**SUNDRY NOTICES AND REPORTS ON WELLS**

OXY USA WTP Limited Partnership

7. If Unit or CA/Agreement, Name and/or No.  
Myers Langlie Mattix Unit

OXY USA WTP LP  
Myers Langlie Mattix Unit #178  
API No. 30-025-11007

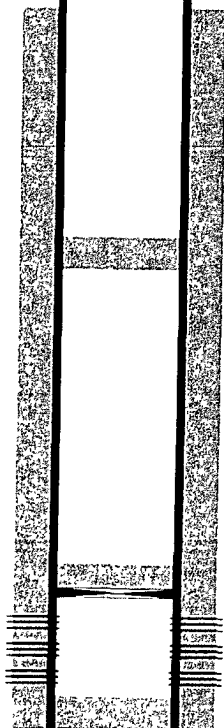
1. Approval is granted to plug this well with the following modifications to the proposed plugging procedure.
2. The plug proposed for 2700' should be moved to 2742' for the Base of the Salt.

**All plugs below the surface plug must be at least 25 sacks of cement and 100' plus an additional 10% for each 1000 feet of depth.**
